USNRDL-TR-582  
17 September 1962

DESIGN MODIFICATIONS AND 1962 COST ANALYSIS  
FOR A STANDARDIZED SERIES OF FALLOUT SHEILDERS

by  
Lewis G. Porteous

prepared for the  
OFFICE OF CIVIL DEFENSE  
DEPARTMENT OF DEFENSE

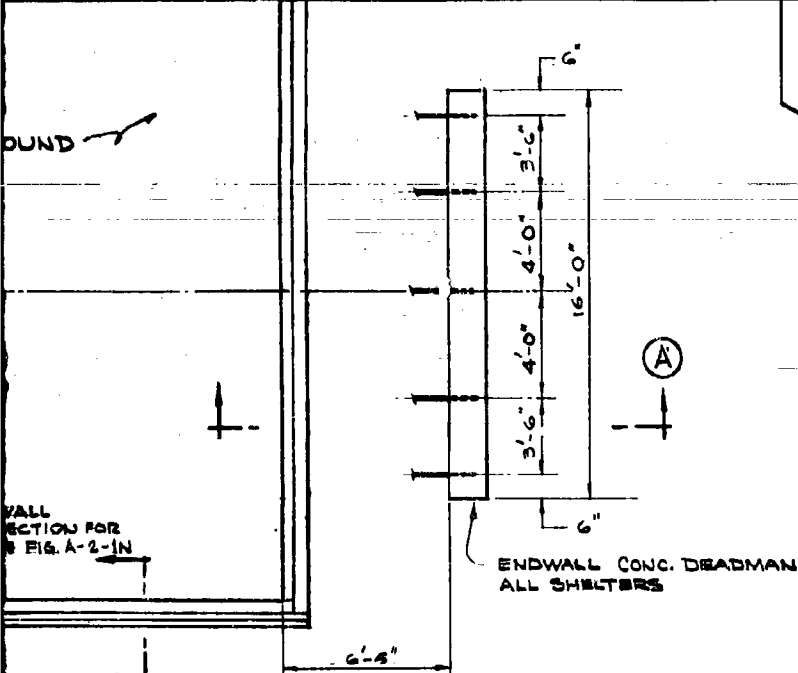
2. The expansion joint filler now specified (Fig. A-2M) is just as adequate as that formerly specified in Ref. 1, but it is less costly.

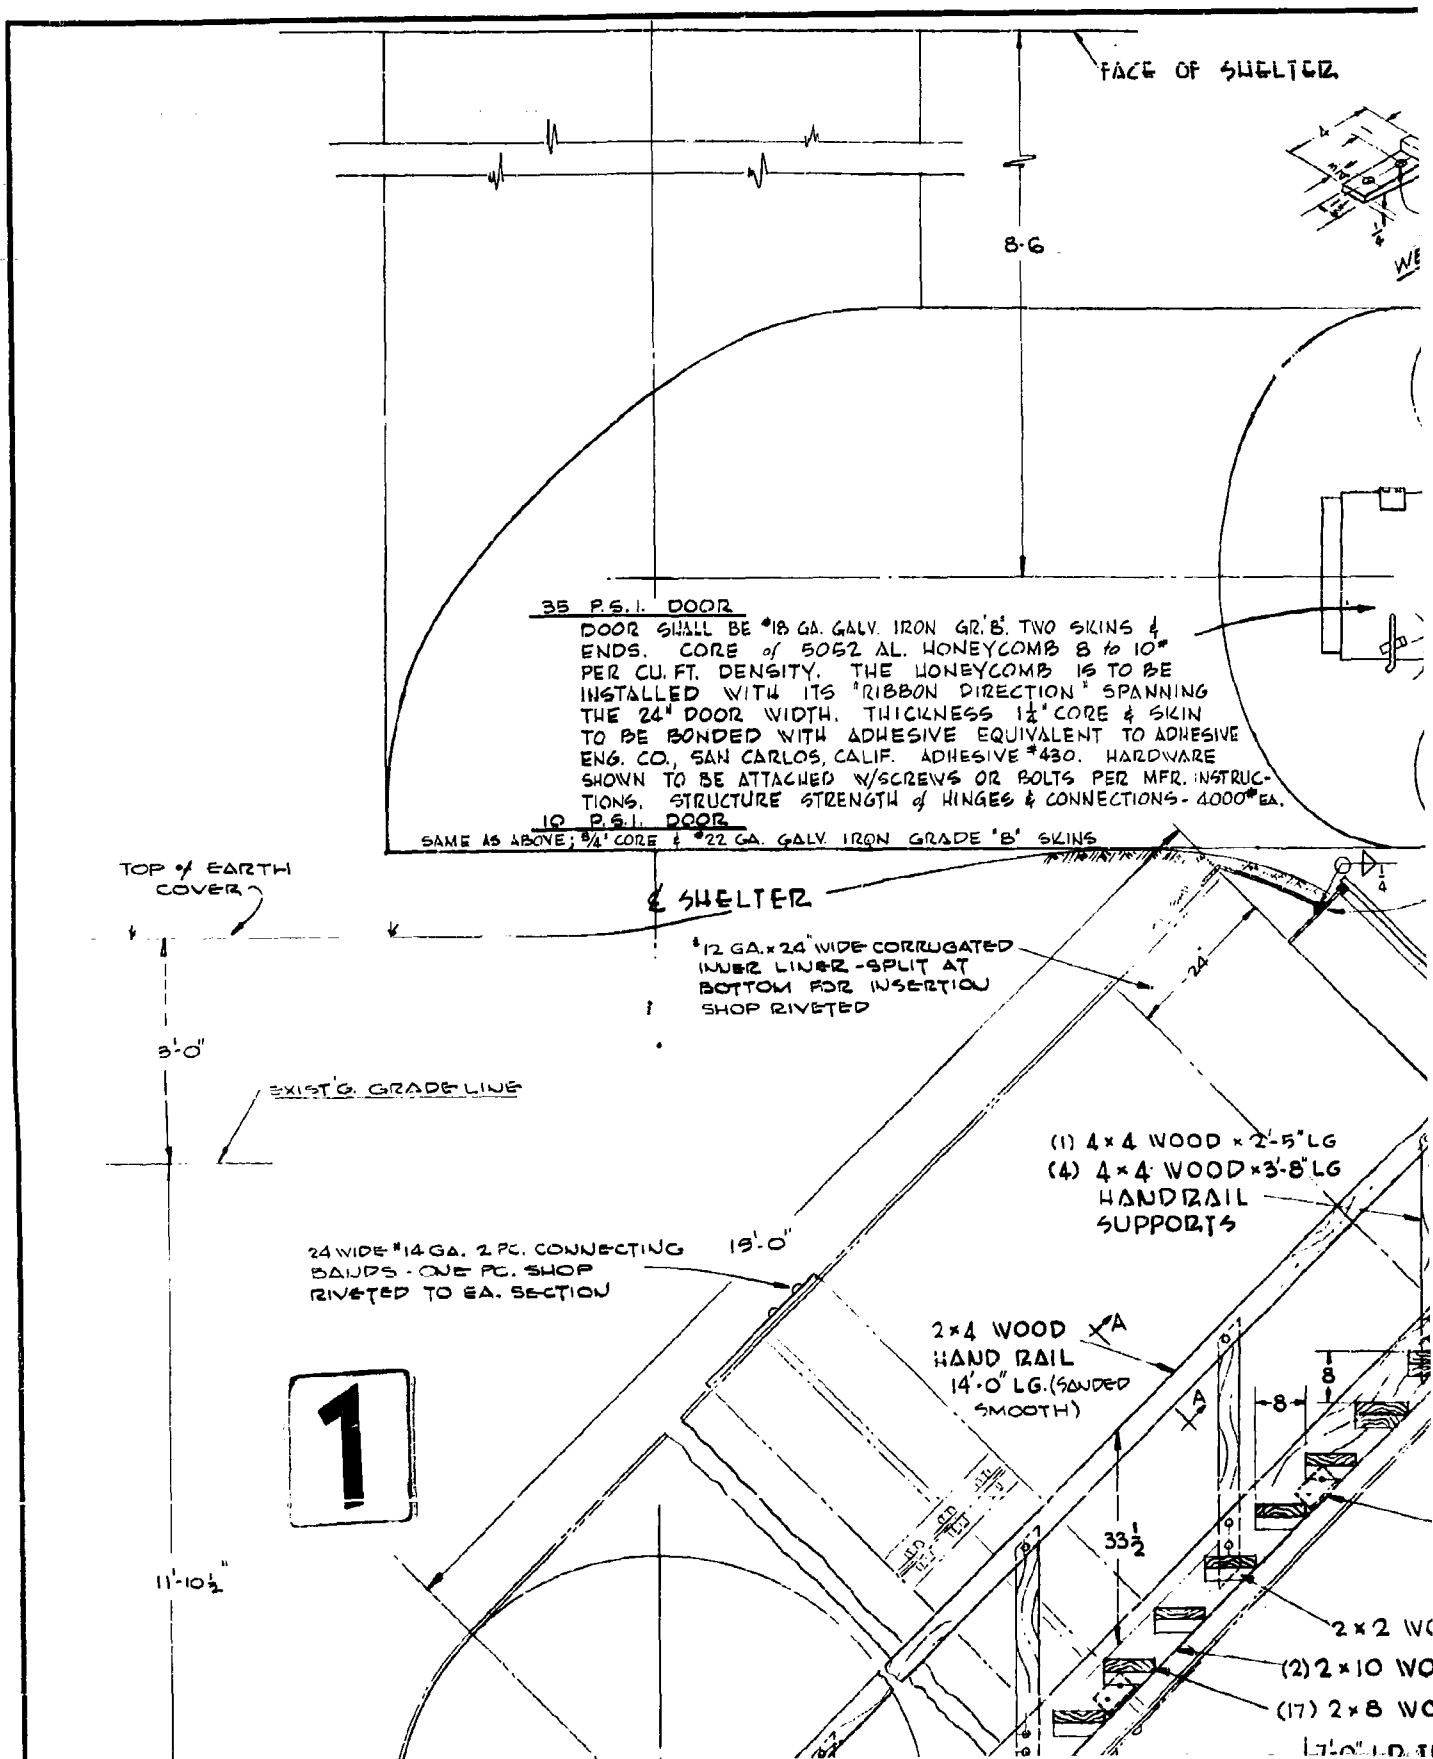
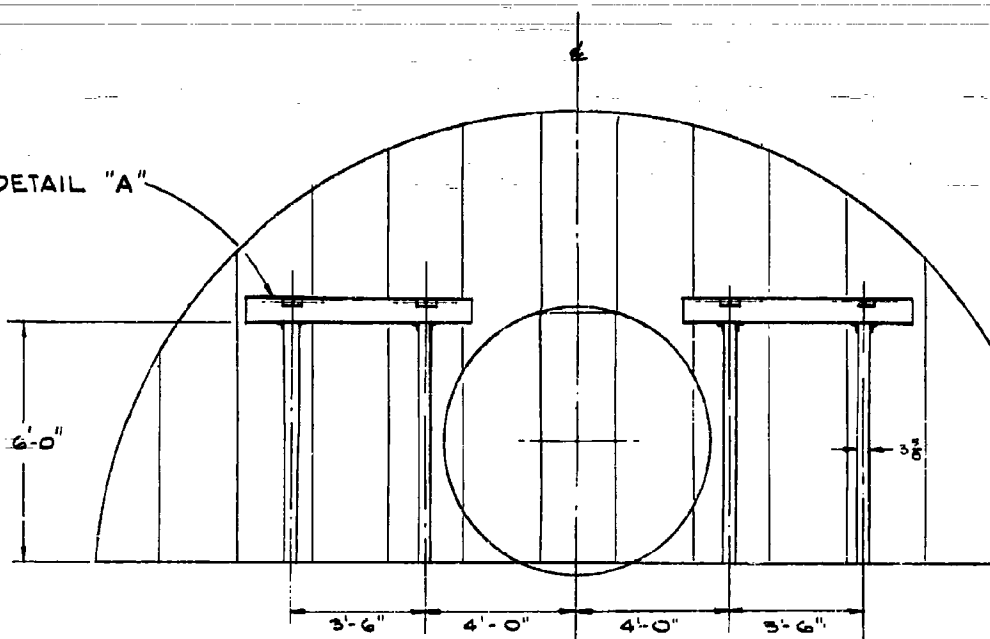
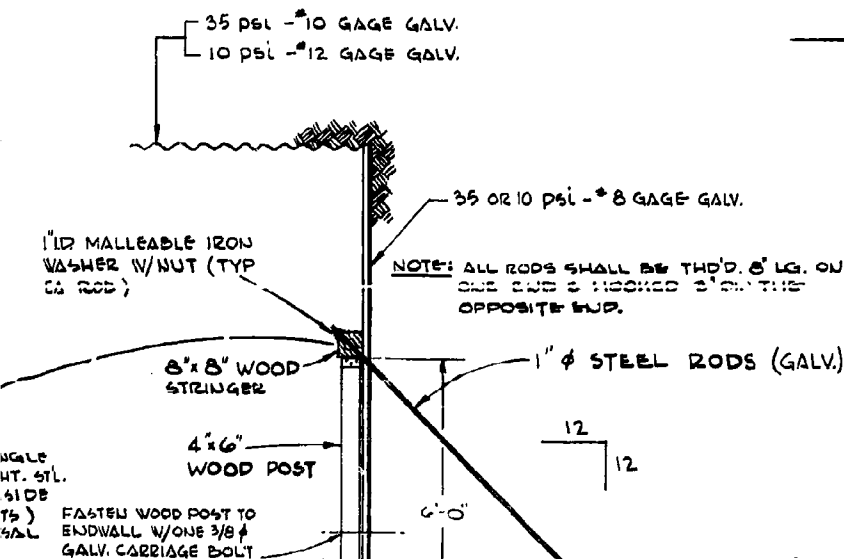
3. Notes have been added to the drawing (Fig. A-3M) on entrance and endwall support details specifying (a) the base metal to be used in fabricating the basic arch structure, the endwalls, and the entranceway; (b) the manufacturing tolerances; (c) the erection procedure to be followed by the contractor; and (d) the basic quality control of workmanship in fabrication and erection.

3. The design of the endwall supports has been modified to reduce costs without decreasing the structural strength.

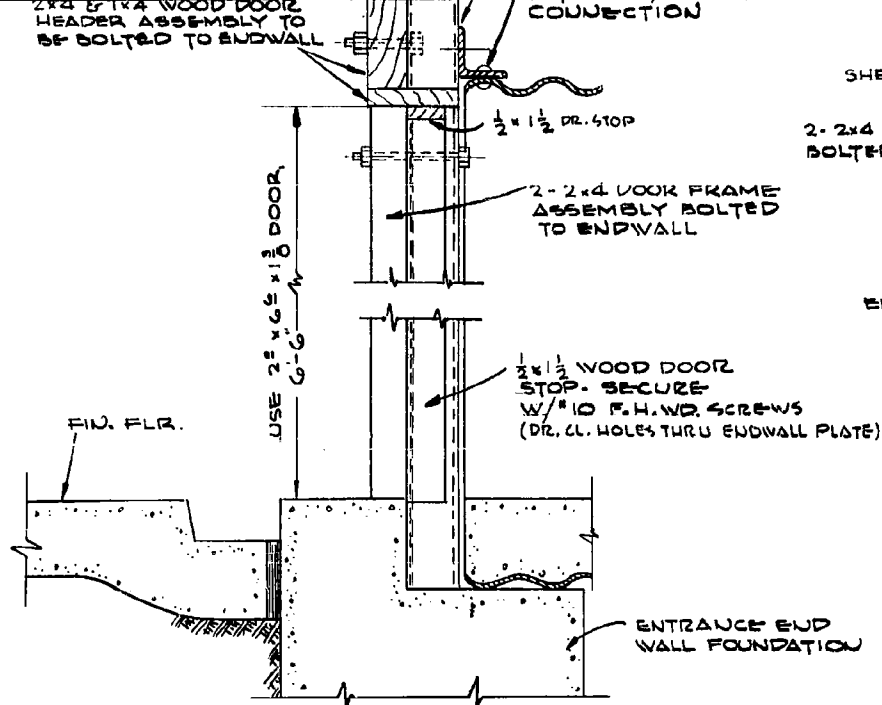
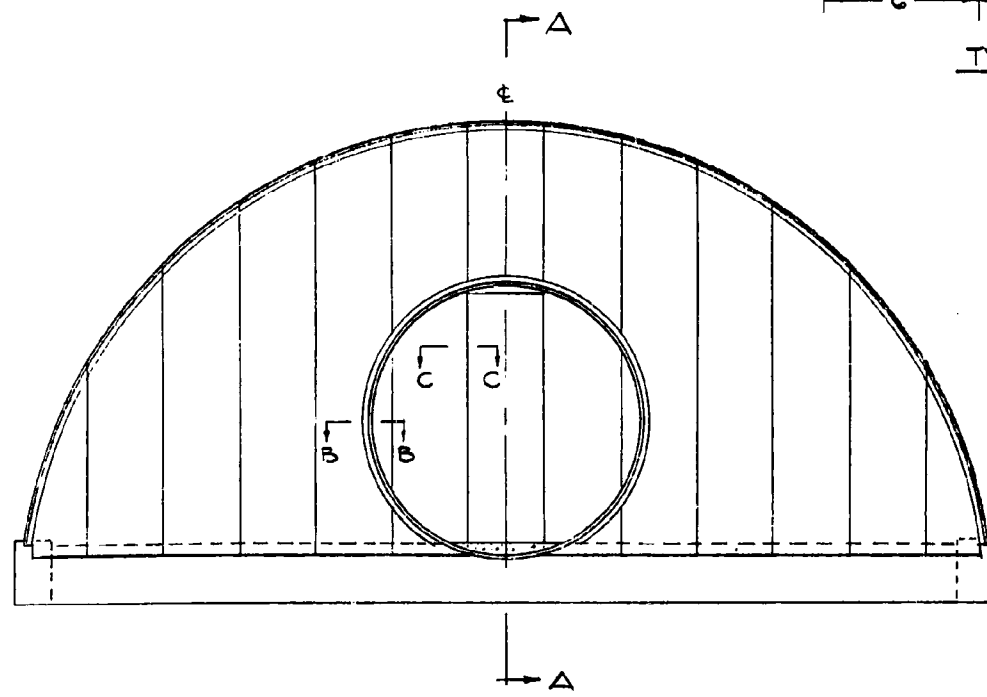
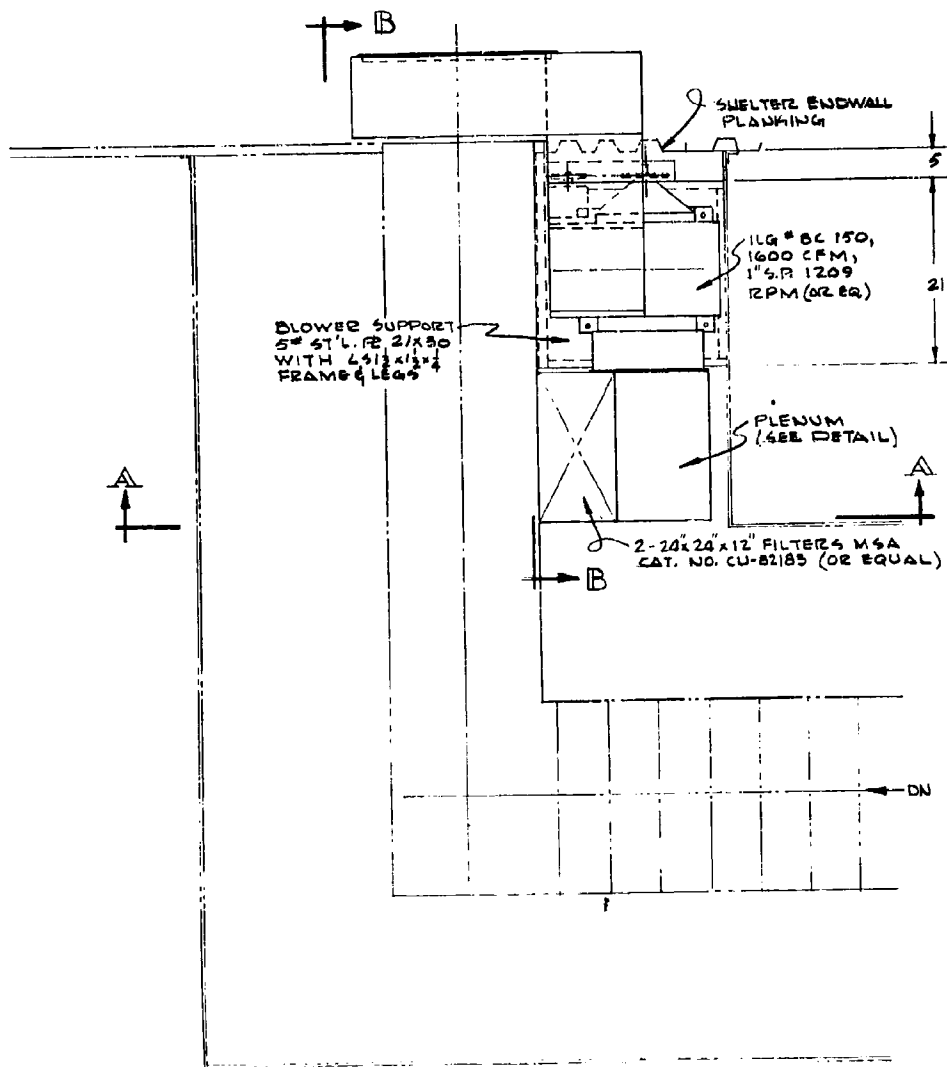
1. With the installation as shown in Ref. 1, investigation revealed that about 50% of the ventilation air was being short-cycled and did not reach the shelter interior. To correct this condition, weather stripping was added to the entrance endwall door, and flashing was installed at the connection between the entry tube and the endwall (Fig. A-5M).

2. The design of the shelter endwall entry door was modified (Fig. A-5M) to obviate its fabrication in strict accordance with the Federal specification. Commercial-grade doors, which can be fabricated at less cost and are satisfactory in performance, can now be installed.
